SUNDRY NOTICES AND REPORTS ON WELLS

8. Well Name and No.
LESLIE FED COM 21H

Matador Request a change in the joint type for the following casing specifications. New Joint specs are below. Spec sheet is attached for the 5.5in casing is attached.

Technical Specifications

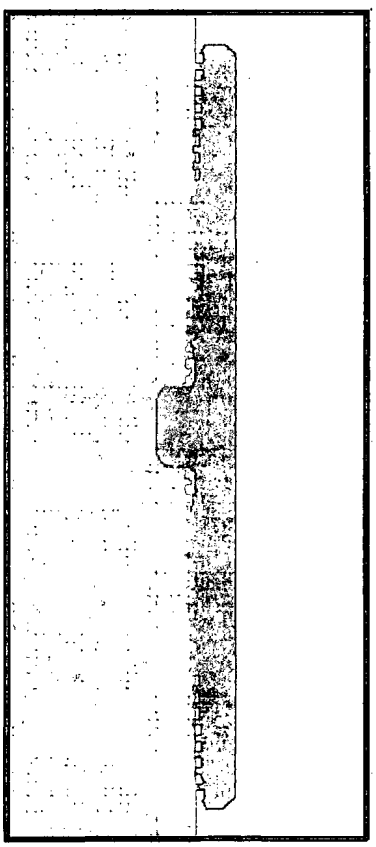
Hole Size: 8.75in; Casing O.D.: 5.5in; MD: 0-13952?; Joint: VAM DWC/C-IS HT Plus
